Technical Bulletin

DP02	TB0024-2008	Elan Motorsports Technologies	
From:	Chip Lewis		
Subject:	2008 Rear Anti-Roll Bar	Date:	March 3 rd , 2008

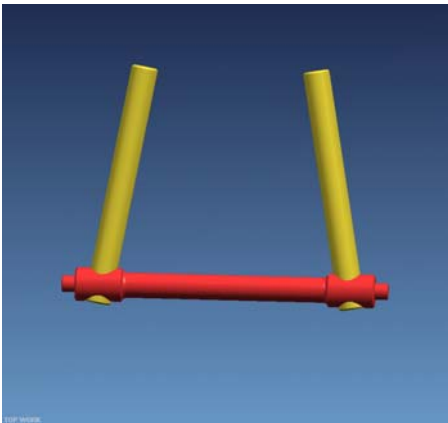
Available to order is a new Rear Anti-Roll Bar, DP02-20-019. The new RARB is an improved version to prevent the breakage that occurred in a few of the previous units. In order to fit the new RARB, a slight amount of grinding may have to be done to the bellhousing, as shown in the second picture. A small trough may need to be ground into the cast edge.
